- 11. Reeder Lake Subdivision 2024 Addition; KPB File 2024-039
Johnson Surveying / Wiley
Location: Reeder Avenue
Cohoe Area**

REEDER LAKE SUBDIVISION 2024 ADDITION Preliminary Plat

**ITEM #11 - PRELIMINARY PLAT
Reeder Lake Subdivision 2024 Addition**

STAFF REPORT

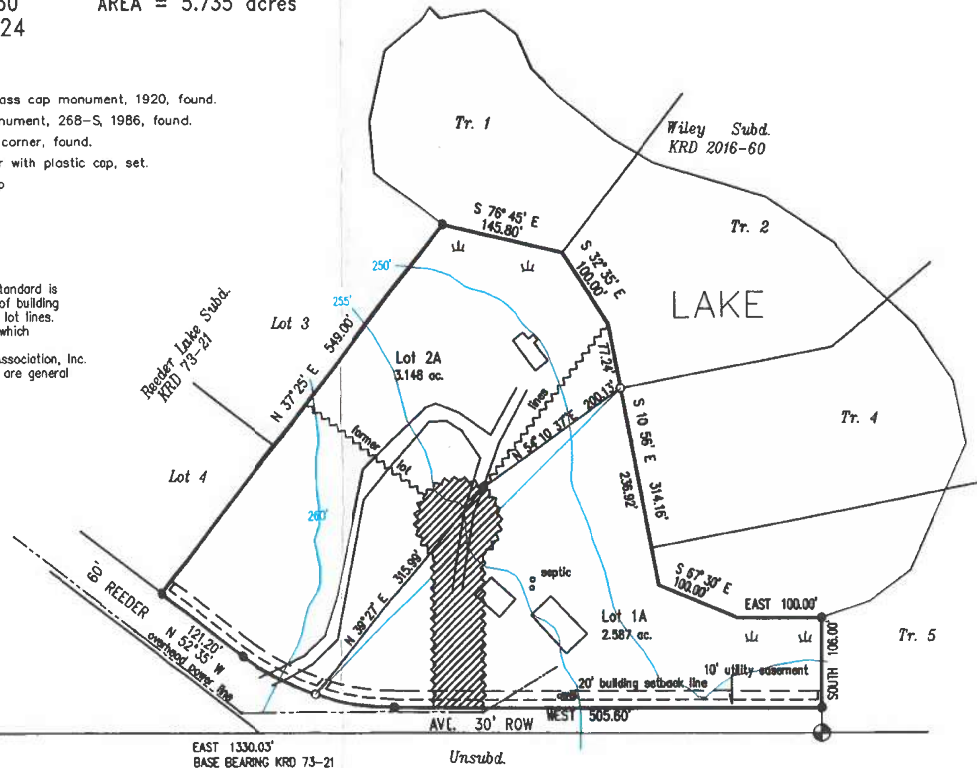
Reeder Lake borders on the north side of the proposed Lots 1A and 2A. A significant border around Reeder Lake is labeled Kettle by the KWF Wetlands Assessment – this area appears to mostly follow the contour near the lake and should be shown on the final plat when submitted.

| Addressing | <p>Reviewer: Leavitt, Rhealyn Affected Addresses: 54800 REEDER AVE</p> <p>Existing Street Names are Correct: No</p> <p>List of Correct Street Names: CIRCE LN, REEDER AVE</p> <p>Existing Street Name Corrections Needed: ON SKETCH ROW IS CIRCLE LN, PLEASE CORRECT TO CIRCE LN</p> <p>All New Street Names are Approved: No</p> <p>List of Approved Street Names:</p> <p>List of Street Names Denied:</p> <p>Comments: ADDRESS WILL NOT BE AFFTECTED.</p> |

Add KN 73-21 Lot 6 to drawing.

Correct "Circle" to Circe Ln
 Add KPB no 2024-039 to title block

Complete Sterling Highway to the north.
 Add Sec 17 to the map.
 Correct "Wayside" to Road.
 The township label has overstrikes

Add KN 73-21 Lot 6 to drawing in the southwest.

Correct Circe Ln in the plat notes

When the contours are removed for the final submittal, plat note #4 can be removed also.
